SAFETY RECALL

SR23-07

DATE :	April 2023	SECTION :	06 ELECTRICAL
SUBJECT:	Hazard Warning Lights Synchronization

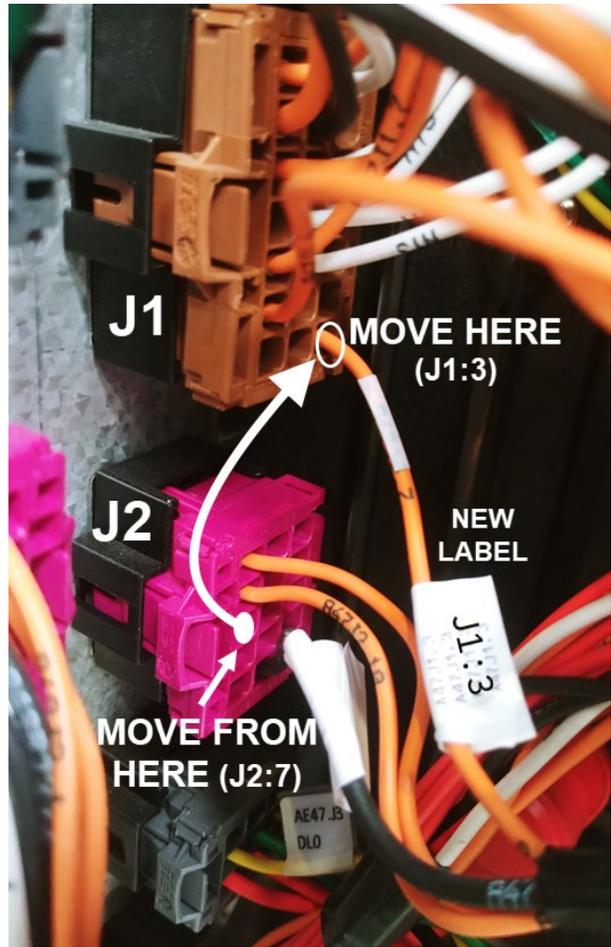
- Locate wire **J2:7** (J2 middle connector)
- Disconnect J2 connector (see note for correct removal procedure)
- Remove the **J2:7** wire using extractor tool **568103** (see note for correct removal procedure).
- Put a label on the wire indicating that it will now be named **J1:3**.
- Reconnect the wire into J1:3 cavity of the J1 (top) connector.
- Reconnect the J2 connector.
